## Pre-lodgement Meeting Notes

**Application No:** PLM2022/0235  
**Meeting Date:** 9 February 2023  
**Property Address:** 53A & 53B Warriewood Road WARRIEWOOD  
**Proposal:** Development Application Prelodgement Meeting  
**Attendees for Council:** Anne-Marie Young, Principal Planner  
Adam Croft, Principal Planner  
Shivani Tapas, Flooding Engineer  
Robert Platt, Development Contributions Officer  
James Brocklebank, Transport Engineer  
Ray Creer, Waste Officer  
Bree Healy, Health Officer

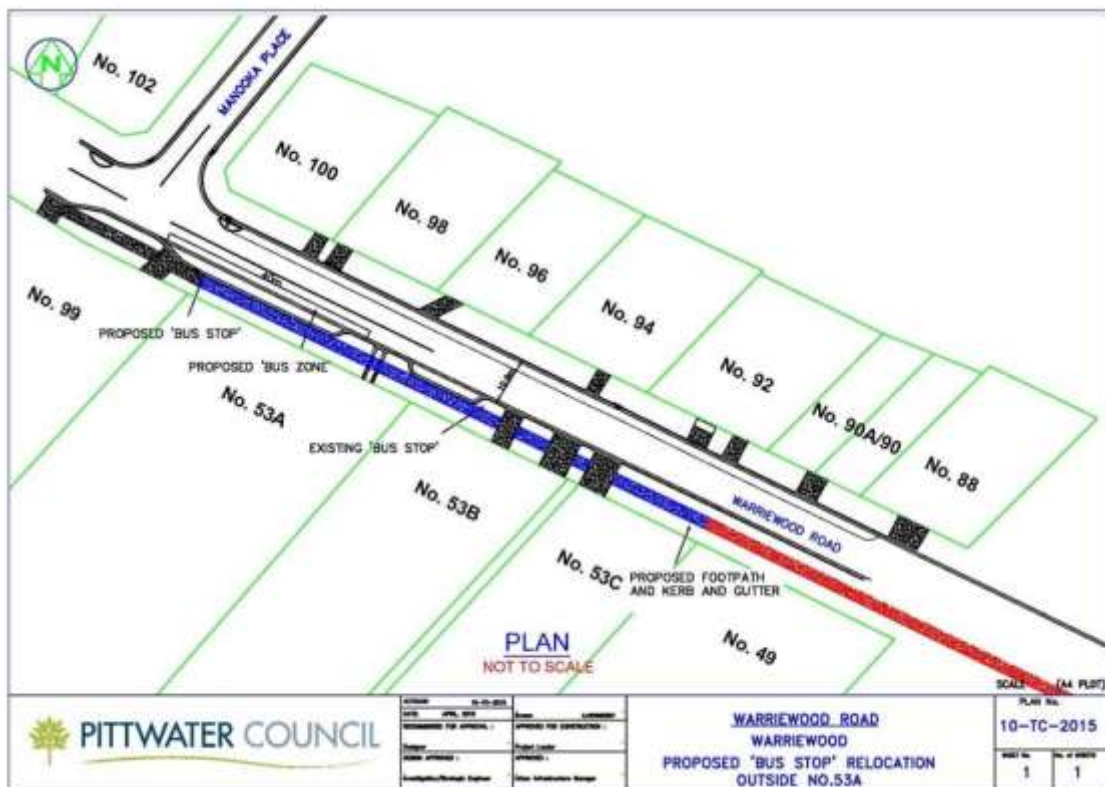
- Although the prelodgement plans are lacking in detail it is noted that the internal roads now proposed are each 7.5m in width generally with 2.5m nature strips which is consistent with widths envisaged in the Warriewood Valley Roads Masterplan (WVRM) for Access Streets. This will allow parking to occur on one side of these roads without impacting upon two way traffic flow.

- There was concern expressed at the previous PLM with regard to the inability of the narrow road proposed to accommodate parking, particularly for any visitors, the 7.5m road widths now envisaged will provide adequately for visitor parking needs associated with subdivision and this is no longer a particular concern.

- No vehicle crossings or offstreet parking have been shown on the prelodgement plans however each residential lot would be expected to have a driveway providing access to offstreet parking for 2 vehicles.

- No swept path plots have been provided to demonstrate turning of trucks at the end of road 1, provision will need to be made for turning around of 10.5m garbage trucks. Reversing back along these roads by heavy vehicles will be unacceptable from a safety perspective. The ability for turning of trucks at the junction of Road 2 and Pheasant Place may also be required given the current lack of rights of carriageway for Council over Pheasant Place.

- It is noted that there are 8 lots fronting Warriewood Road. The WVRM seeks to minimise driveway access points along Warriewood Road and where possible access should be provided from internal access roads. Lots 9-12 appear capable of being accessed from the internal roads while lots 13/14 and 15/16 could be accessed via shared driveways i.e only 2 driveways to Warriewood Road.

- The WVRM requires the provision of a 2.1m shared path along the full Warriewood Road frontage of the site. There is also a requirement for a 2.5m wide shared path along the creek boundary at the southern edge of the site (understood to be the outer creek line corridor). These shared paths will need to connect with and match widths of existing approved shared path connections through Lot 3 DP 1115877 (known as 53C Warriewood Road) and Lot 106 DP 1151062 (known as 16-22 Lorikeet Grove). It is noted that the nature strip at the north western corner of the lot narrows to 1.5m in width. This is probably to match the nature strip widths for the already constructed section of Lorikeet Grove west of the site. This may result in the shared path straddling the road reserve and the residual lot. A 1.5m wide footpath is also required along the north side of Lorikeet Grove matching the alignment of existing footpath connections on adjacent lots. Details for the above should be resolved at DA stage.
